Addendum No. 1

RE: Contract # C205128

Rockingham County (BR-0096)

BRIDGE #780176 OVER NC-14/NC-87 ON SR-1700 (FISHER HILL RD)

**RETAINING WALL
NO.1 AND 2 MSE WALL-
NOTES & PRECAST PANELS
LEVELING PADS STEP DETAIL**

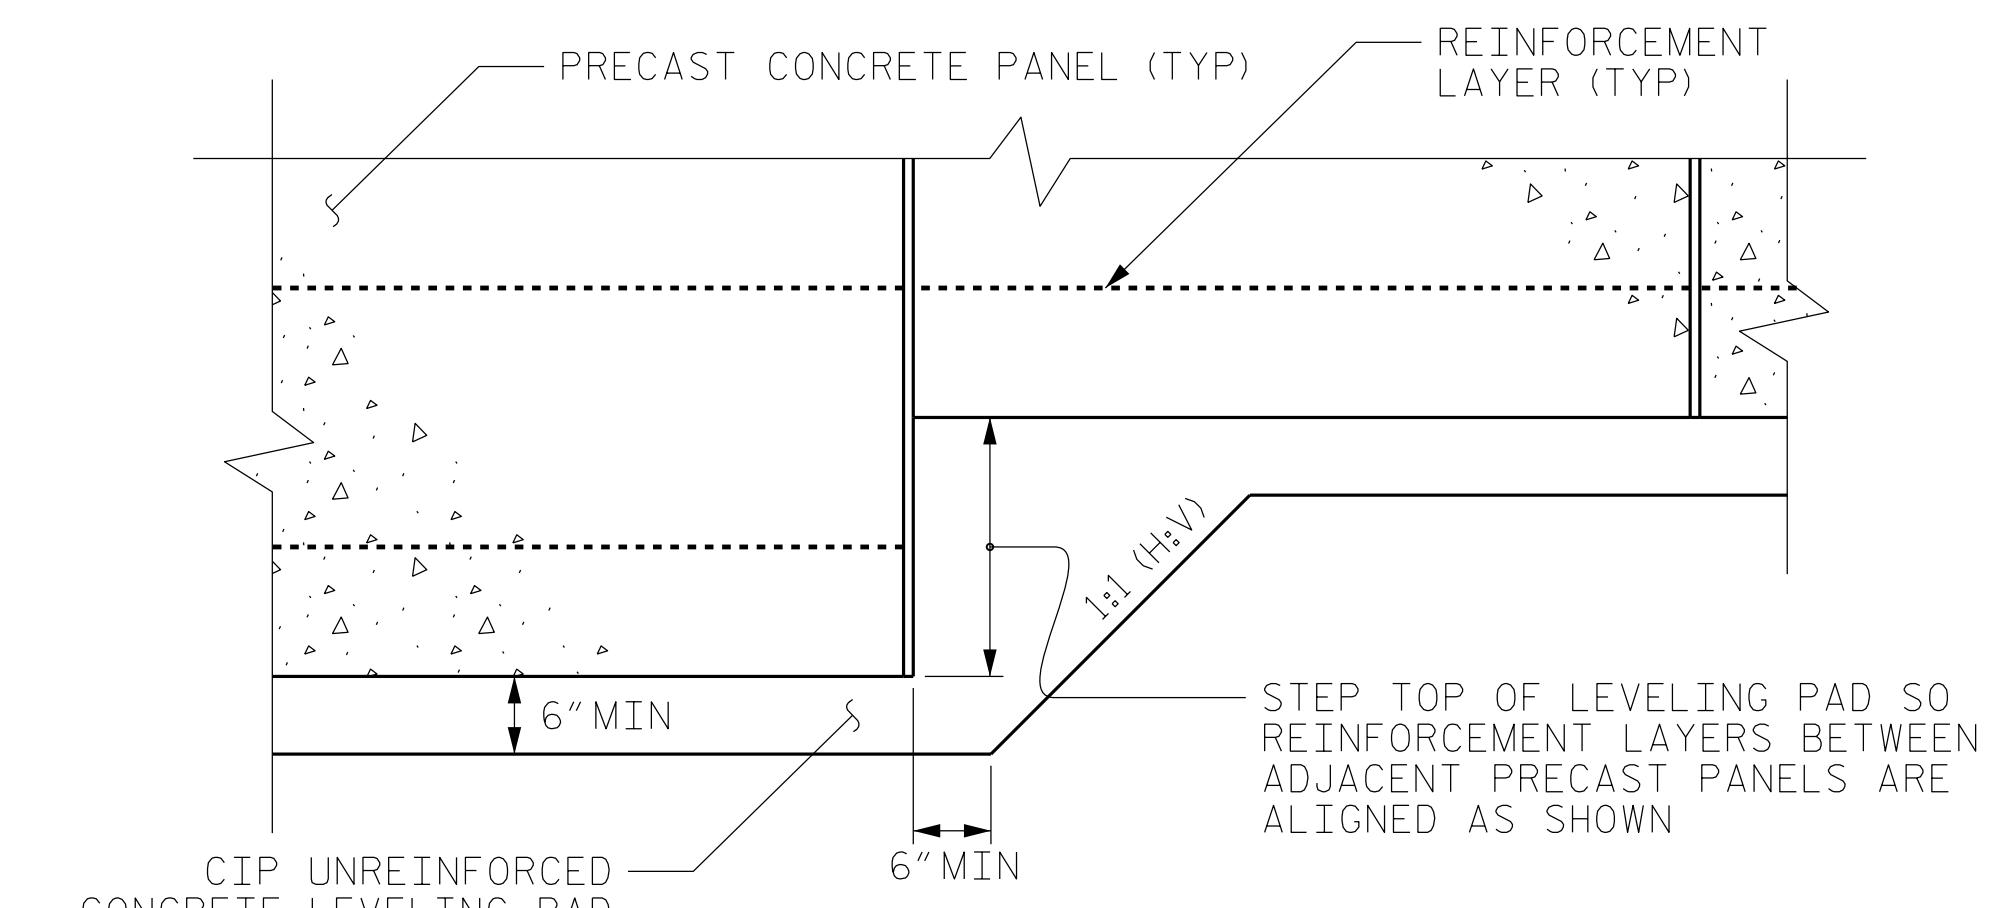
Sheet No.	Revision
W-4	NOTES have been revised addressing the minimum wall reinforcement and adding a minimum embedment.

- 1) DESIGN HEIGHT (H) = WALL HEIGHT + WALL EMBEDMENT
- 2) DESIGN LIFE = 100 YEARS
- 3) MAXIMUM FACTORED VERTICAL PRESSURE ON FOUNDATION MATERIAL = 5,100 PSF
- 4) MINIMUM REINFORCEMENT LENGTH (L) = 0.7 H OR 6 FT, WHICHEVER IS LONGER
- 5) MINIMUM EMBEDMENT DEPTH = 2 FT
- 6) REINFORCED ZONE AGGREGATE PARAMETERS:
